TI\_2407: New alternative control board (CPU board)

iVario

18.06.2024

## New alternative control board

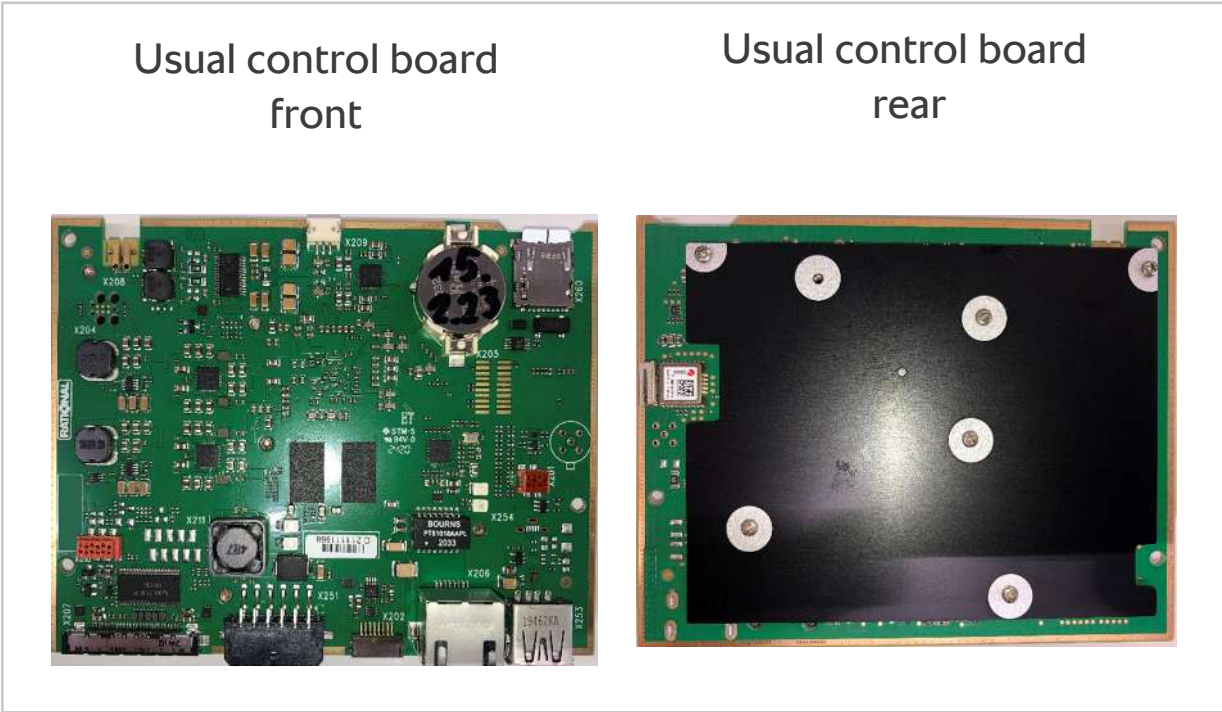
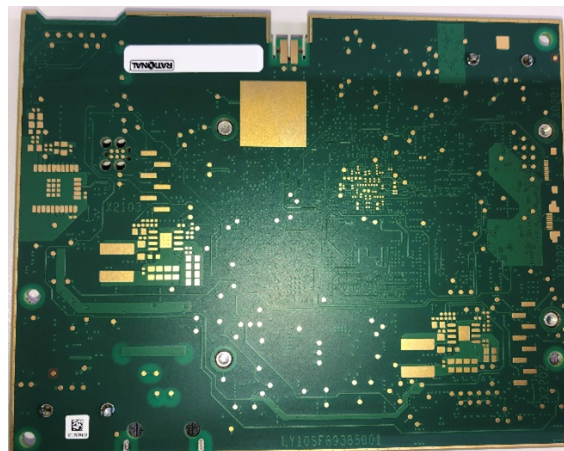
We would like to inform you that, since 03/06/2024, we have been using a new control board, Part no.: 42.00.251P as an alternative to the existing control board. This board is used exclusively for newly produced units and can only be operated with software version LMX-2.13.10 or higher.

Both variants of the control board are now installed ex works. Only the previous usual control board will continue to be sent as a service part. This is compatible during service work. It is not possible to convert the new alternative control board in other units (in the event of service) and the board must therefore always be replaced in this case.

There are no LEDs for error analysis on the new alternative control board. The existing Reset-to-Spare Part software cannot be used on the new control board either.

In the event of a fault, please contact RATIONAL Service and, if a replacement is required, always return the faulty control boards to RATIONAL, describing the fault as precisely as possible.
